# **Conceptual Review Agenda**

# THE SUMMIT ON COLLEGE CONCEPTUAL DESIGN REVIEW SUBMISSION

Re: Choice Center - Parking Garage

Re: 218 Smokey St - Solar Energy System

SP2 PROPOSED GRADE LEVEL OVERLAY ON SITE PLAN

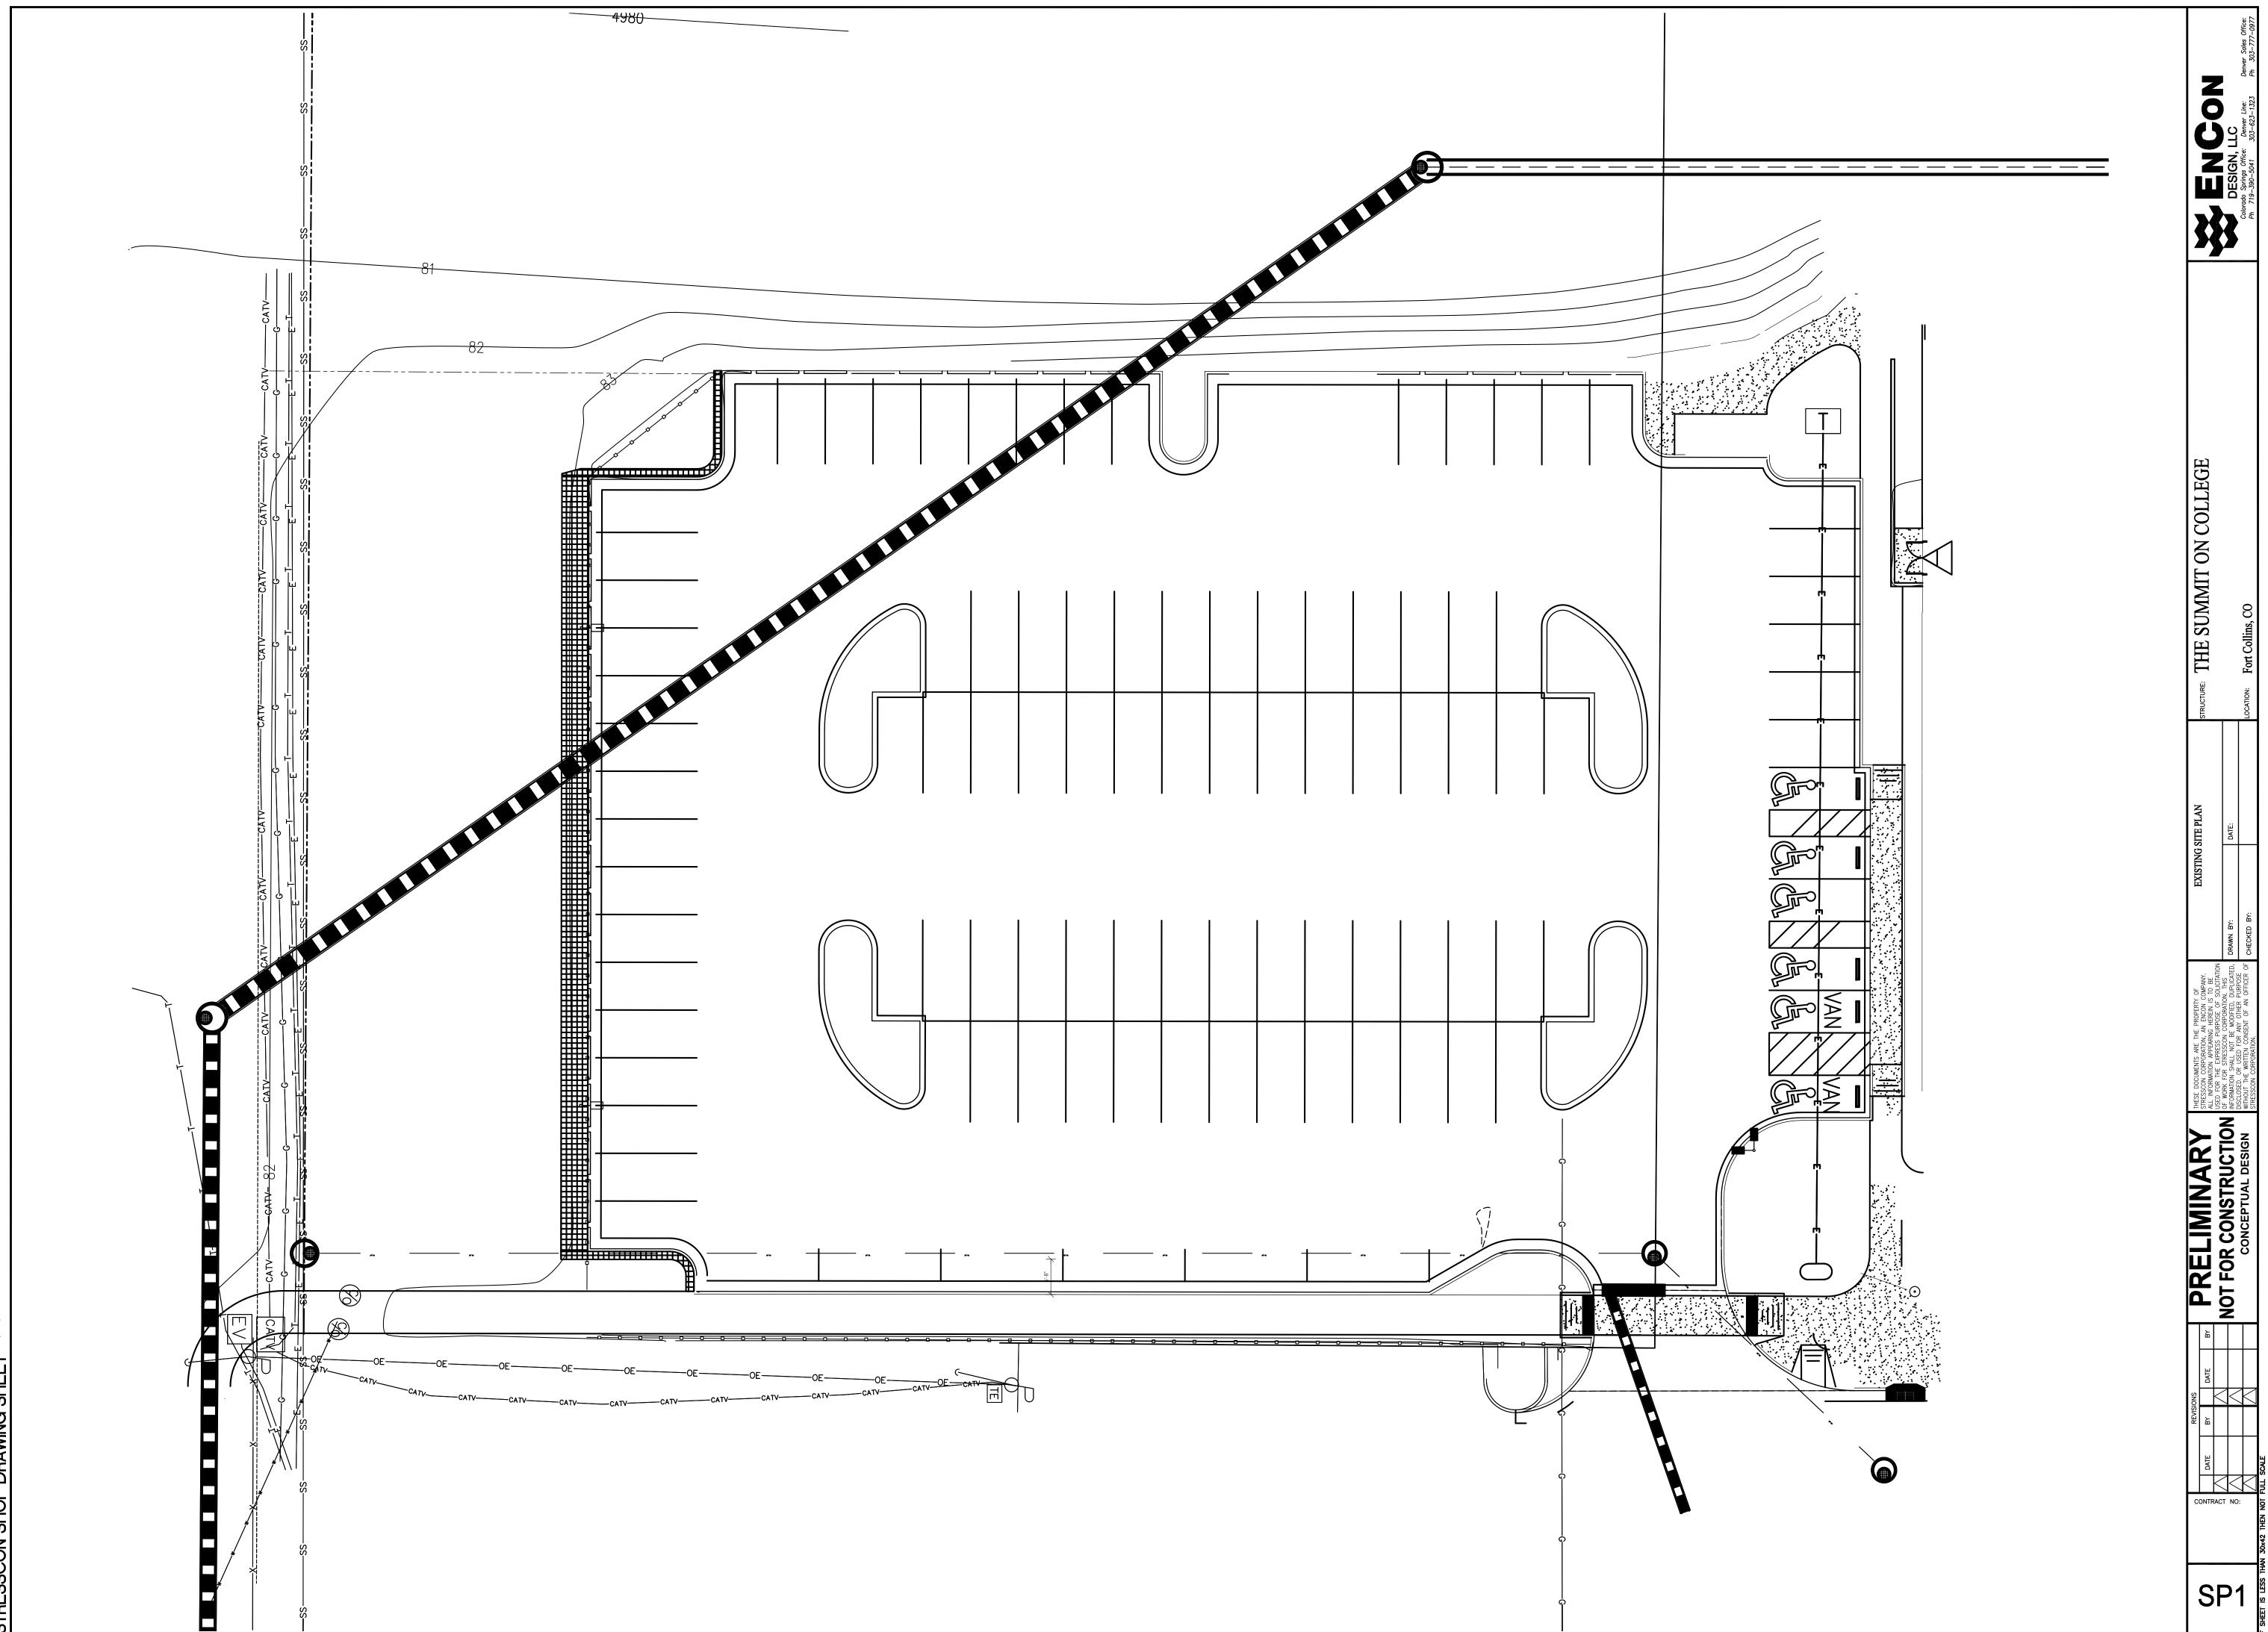
- 1. Without a true site plan it is difficult to see where the garage structure will lie other than 15' from the east property line.
- 2. Please consider adding ground level bicycle racks, as well as "cages," to lock bikes within.

- 4. The site plan needs to be expanded to include a larger contextual area so that all access, circulation and compatibility issues can be evaluated. For example, the proximity to the adjoining commercial properties needs to be ascertained. Also, since West Stuart is a public street, please indicate how a driver can reverse direction without having to enter the garage. And, how close would the west elevation be in relation to the Bus Rapid Transit system?
